Work Order ID 139481

Item Name: Quick Release Heli-Utility-Basket™ Long, HD Lid, Spacepod™/Squirrel Cheek Comp.

DART SERVICE INSTRUCTION

TO AMEND INSTALLATION INSTRUCTIONS D350-607-3 Rev.D,
INSTALLATION INSTRUCTIONS D350-607-4 Rev. C AND
INSTRUCTIONS FOR CONTINUED AIRWORTHINESS ICA-D350-607 REV. 6
REF TCCA STC: SH94-14
REF FAA STC: SR00213NY
REF EASA STC: EASA.10016996
REF BRAZILIAN STC: 2007S03-03/-04/-05/-06

FIGURE 1: INSTALLATION OF D4775-041 FWD STRUT

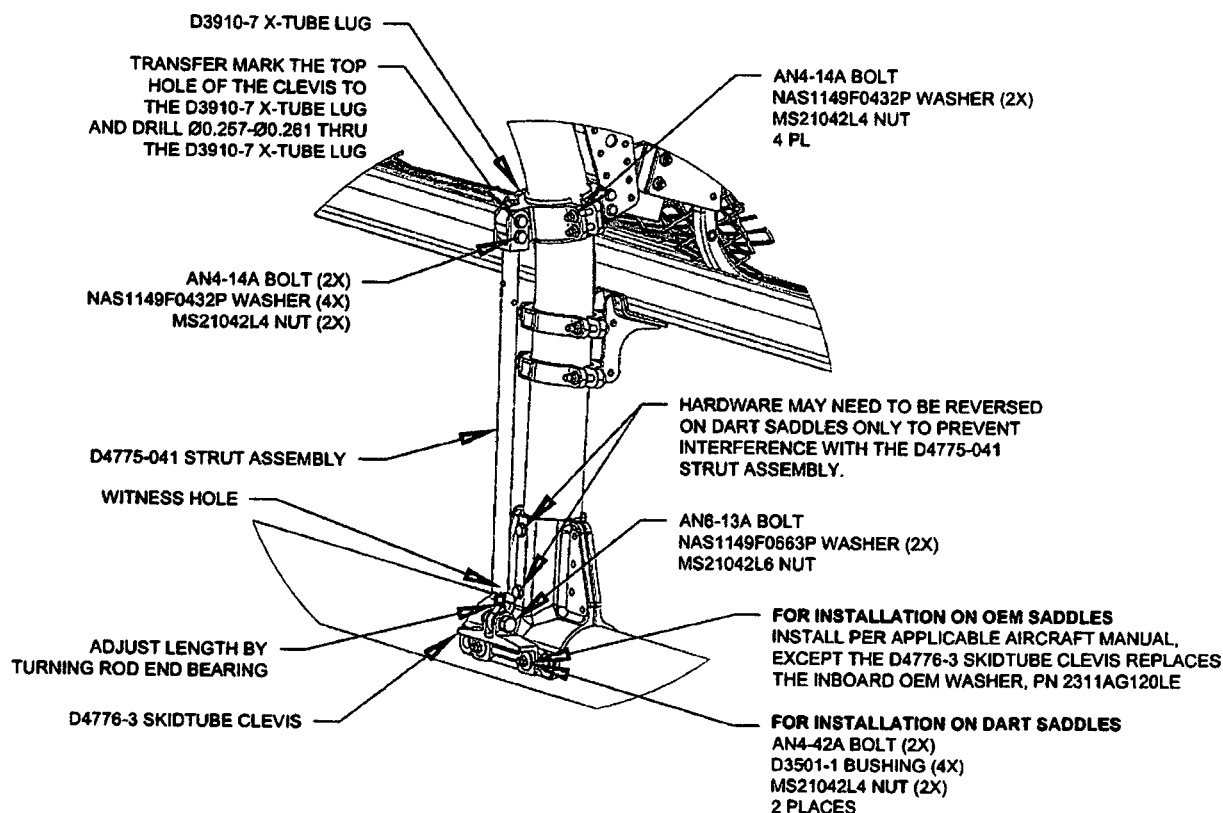
- 3.1 Substitute the Forward Lower D3910-5 X-Tube Lug with the D3910-7 X-Tube Lug as shown in Figure 1.
- 3.2 Install the forward D4775-041 Strut Assembly. Transfer mark from the upper hole on the clevis of the D4775-041 Strut Assembly to the D3910-7 X-tube Lug and drill thru the lug $\varnothing 0.257$ - $\varnothing 0.261$ as shown in Figure 1. Touch up chemical conversion coating per MIL-DTL-5541. Check the witness holes located at the bottom end of the D4775-041 Strut Assemblies to ensure that the thread from the rod end extends past the witness hole.
Torque MS21042L4/-4 nuts to 50-70 in-lbs (5.7-7.9 N-m). Torque MS21042L6/-6 nuts to 160-190 in-lbs (18.1-21.5 N-m).
- 3.3 Complete the installation in accordance with Installation Instructions D350-607-3 Rev. D or D350-607-4 Rev. C.
